# Technical *data*

CT 939 K2/K3 & CT1120K1 timing belt kit, used for example in:  
VW / Audi 2.5 TDI 5 cyl.

**Fig. 1  
Washer**

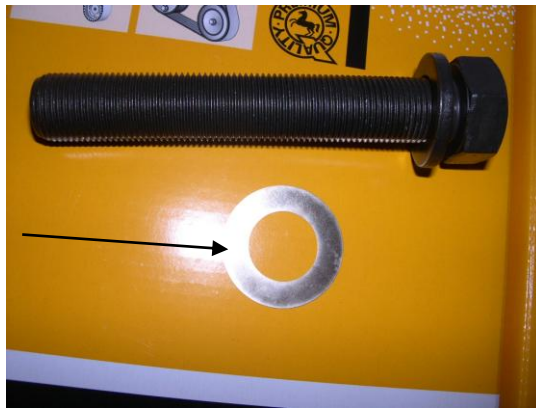
In accordance with the updated equipment status, the timing belt kit contains a thin washer (diamond-coated) that was not previously installed in the vehicle.

According to the VW/Audi catalog, this special washer (4) is to be installed between the crankshaft drive wheel (3) and the torsional vibration damper (5). This is intended to improve the co-efficient of friction.
